MEMORANDUM

From:	Tina Cuss Ecology Officer		
Service	WBC Ecology	App No:	242953
Address:	The Horns Inn, Crazies Hill, Wargrave, RG10 8LY.		
Proposal:	Full application for the proposed change of use of part of the upper floor to guest accommodation (Use Class C1) and part to flexible Class C1 and E use; erection of a replacement gazebo with PV panels, removal of decking and 2 no. existing sheds and erection of 1 no. shed, plus landscaping and external alterations to the building including changes to fenestration and erection of a single storey canopy roof to the side.		
Type of Development:	Other Change of Use		
Site Visit Made:	No

Summary Of Recommendations

Google Map View to show locations of surveyors.

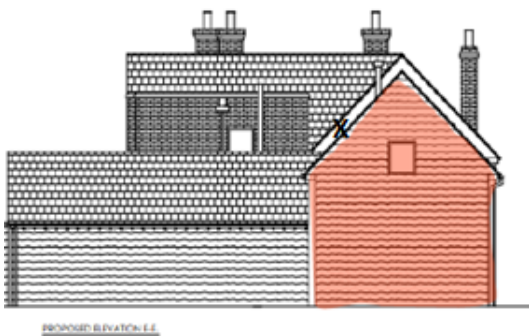
Arbtech state that four surveyors are required to provide full coverage of the building. For the emergence survey Chase Ecological consultancy's surveyors were not located in the car park opposite the northeastern slate-clad elevation and 1 was positioned further to the northwest beyond the gazebo further from the rear of B1. Chase Ecology's surveyors were equipped with EMT 2 Pro/Nightfox infrared cameras and no additional static cameras appear to have been used, survey locations added or amended following recording Common pipistrelle emergence on the 2nd survey on 10 August. Emergence Survey Section 5 Phase 2 Activity Survey does not make clear which bats were recorded, observed or filmed.

Emergence Two

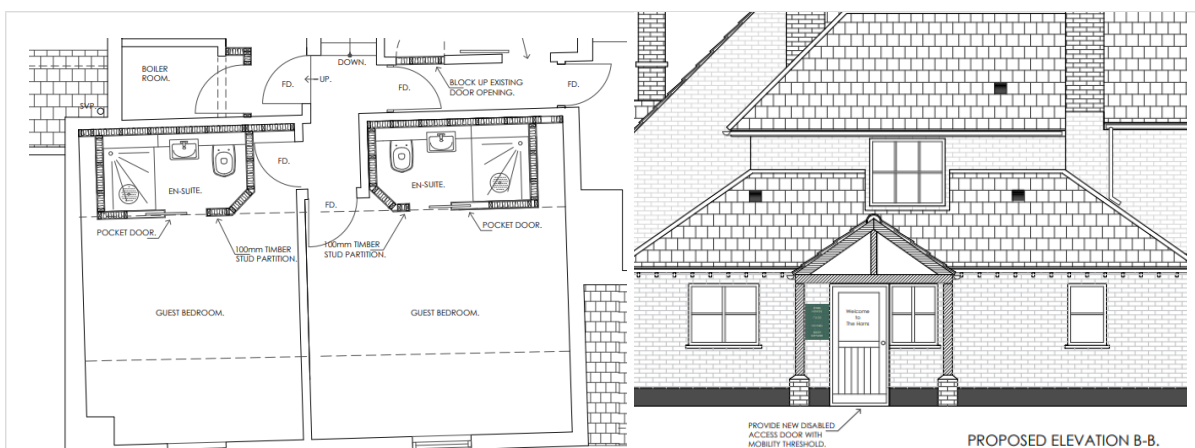
The Emergence Survey Report proposes that no European protected species licence will be required if the avoidance measures in appendix 1 are maintained at all times. The red zone on the rear northern elevation is shown adjacent to but not to include the “*Nort/East facing lower roof coverings*” shown in the photograph of emergence point two. The red zone shows the northwest facing barn roof which extends well below the Emergence point 2 identified by the yellow star on the lower part of the rear elevation slope of the main roof. I therefore disagree that not undertaking works in the proposed red zones will avoid disturbance, impacts or modification the Bat Roost 2. As a result, the application and emergence survey fail to demonstrate that there would be no requirement for a Europeans protected species mitigation licence.

I request that the Emergence Survey Report is corrected and also updated to take account of direct and indirect impacts of the development proposals to install first floor ensuite bathrooms adjacent to Roost 2. In addition, the revised assessment must take into account the ventilation for the ground floor toilets and first floor kitchen shown the slate roof and west-facing tiled roof above, as shown in Proposed Elevation B-B.
